UNITED STATES PATENT AND TRADEMARK OFFICE

| Office Action Summary | Application No. 10/574,541 | Applicant(s) STROH ET AL. | |

DETAILED ACTION

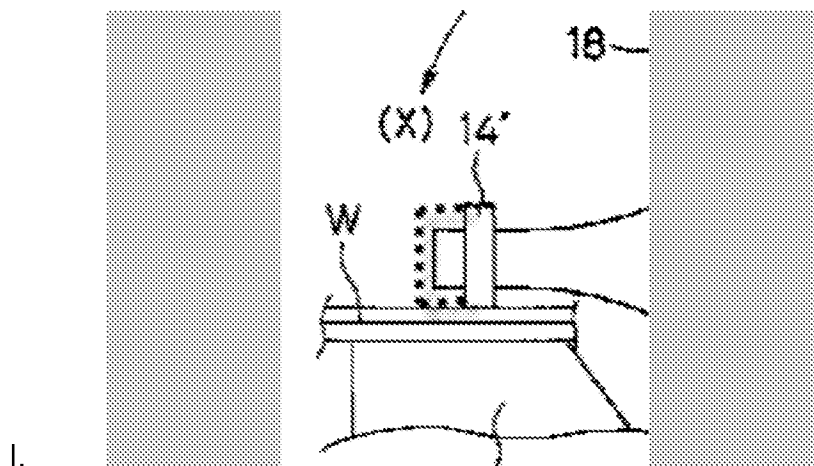
- d. Regarding claim 1, Tamamoto discloses an ultrasonic welding device in the form of a horn 14 (i.e. sonotrode) in Fig. 4. Feature 14' represents the working surface, which is perpendicular to the horn's longitudinal axis and a reinforcement element is shown on the front surface of 14'. The front surface runs perpendicular to the working surface and includes reinforcement. The design of the device protects the horn from being deflected (English abstract).

k. As best understood in view of the 112, 2nd rejection above, Tamamoto's reinforcement protrudes from peripheral edge of the front surface. It would have been obvious to have the reinforcement protrude from entire front surface as shown by the dotted line below, and this would include the edge of the working surface as well. Such would have been obvious because there are only a finite number of predictable projection manners (partial surface, multiple reinforcements from partial surfaces, or entire surface), and a person of ordinary skill in the art would have selected any one of above to minimize undesirable deflection.
